RE: 260 Shawomet Av, Warwick RI- Availability And Permission to Connect to Sewers  
Plat 334 Lot 0018

SURVEY AND PLAN FOR PISTOCCO PLAT 256 SHAWOMET AVENUE WARWICK, RHODE ISLAND PLAT 334 LOT 19	
NRC ASSOCIATES P.O. BOX 14459 EAST PROVIDENCE, RHODE ISLAND 02914 (401)954-0206	
REVISION	DATE
TOPOGRAPHY	MAY 27, 2024
RAIN GARDEN	JUNE 18, 2025
FINAL PLAN(CRMC)	OCT. 30, 2025
FINAL PLAN(CITY OF WARWICK)	DEC. 12, 2025
DRAWN BY: S.S.R.	CHECKED BY: N.Y.P.
APPROVED BY: N.Y.P.	DATE: MAY 23, 2023
SCALE: 1"=20'	FILE NO: SHAWOMET AVENUE
1 of 1

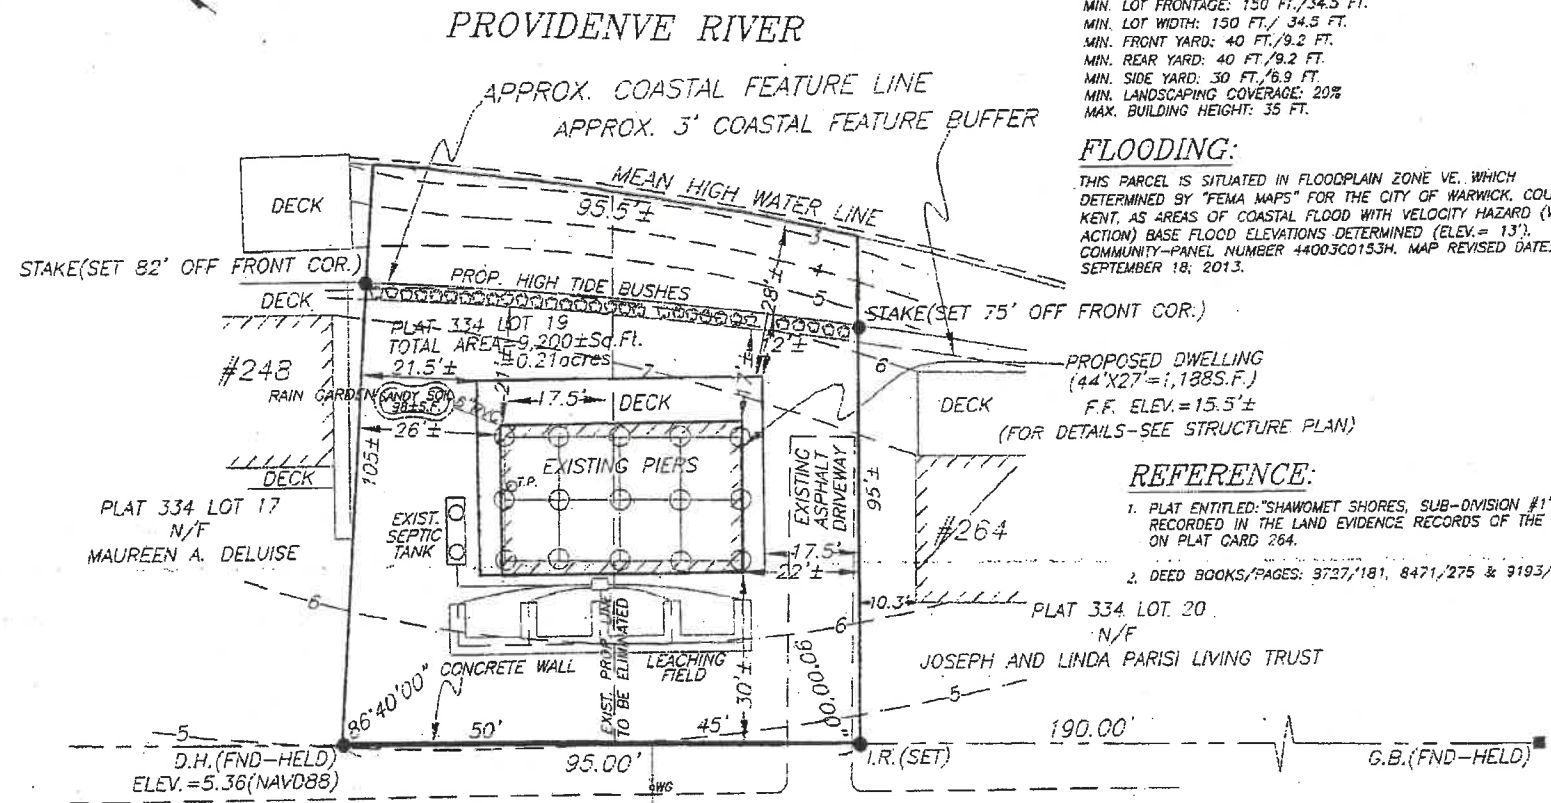
- Stormwater management/treatment. *The survey ("Administrative Subdivision for Pistocco Plat...", prepared by NRC Associates and last revised June 16, 2025) you forwarded to me yesterday has been added to the file. This survey shows a rain garden on the northwest corner of the lot. The proposed rain garden has not been reviewed for compliance with the RI Stormwater Management, Design and Installation Rules.*

- Buffer Zone Requirement. *The survey forwarded to me yesterday does not show the buffer zone.*
- Setback Requirement. *The survey forwarded to me yesterday does not show the setback.*

At our June meeting we discussed showing what you are proposing for a Buffer and a Setback. Neither is shown on the plans. As we have discussed multiple times, a new dwelling on this lot requires a 25 foot vegetated Buffer Zone and an addition 25 feet beyond that as a construction Setback (Setback measures 50 feet from the Coastal Feature). This proposal does not meet those requirements, and a plan showing the project must depict the proposed Buffer and Setback. The Variance request must address the relief requested from the requirements.

Please provide the stormwater management sizing calculations so staff may confirm that the proposed rain garden is appropriate.

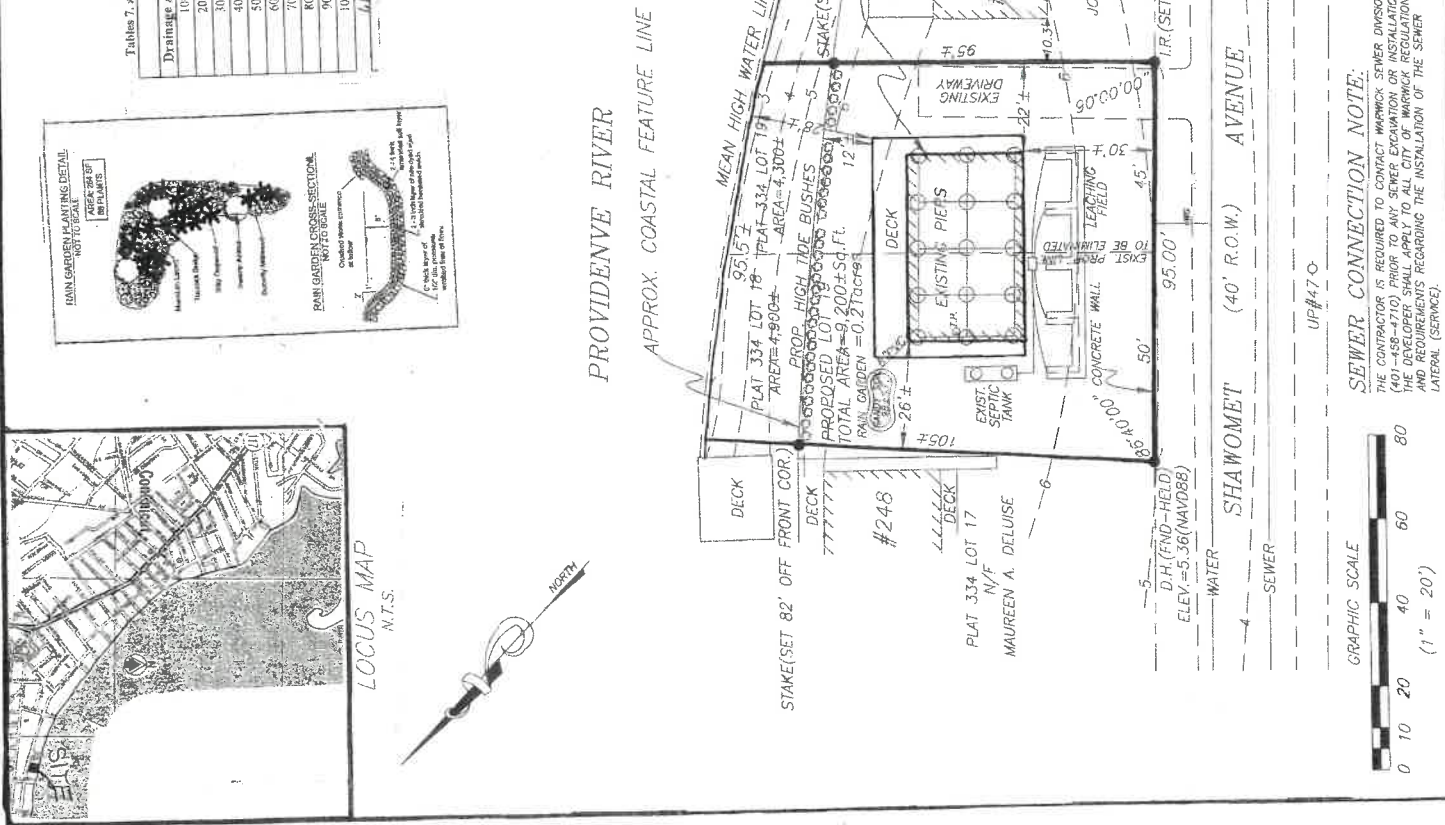
Please provide a plan which depicts the Coastal Feature. The submitted plans submitted show measurements from Mean High Water, which is not the inland edge of the Coastal Feature.

For a lot of this size on Type 1 water, a Buffer Zone of 25 feet, as measured from the inland edge of the Coastal Feature is required. Further, a Setback of 50 feet, as measured from the inland edge of the Coastal Feature is required. Neither the Buffer or Setback (or the Coastal Feature, as noted above) is shown on submitted plans.
